Community Information Meeting Summary Report

February 13, 2020
6:00pm – 8:00pm
Marcon Developments
2025 St Johns Street, Port Moody

Final Version Date:
March 4, 2020

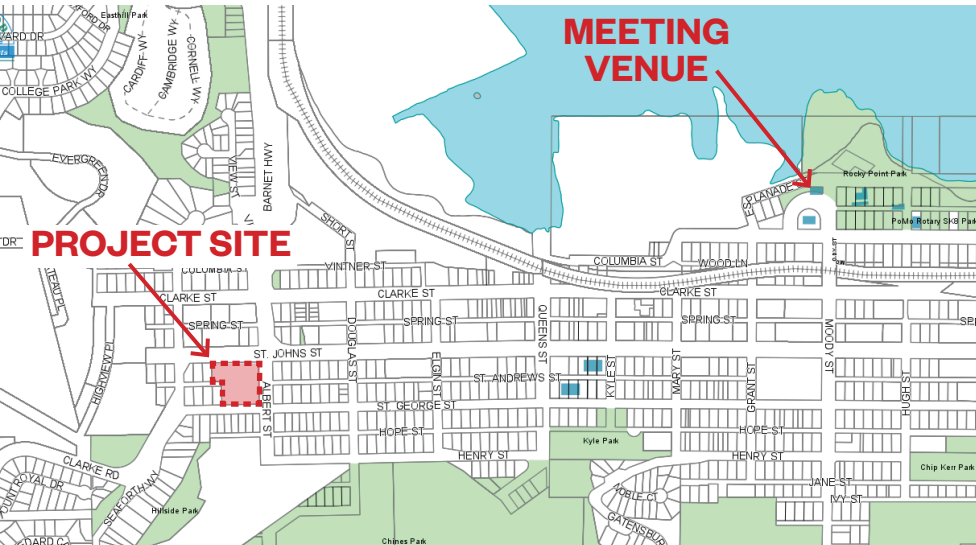
- 1 The image for the proposed 'Public Art' suggestive of another art piece on a pole. Is this is what was imagined
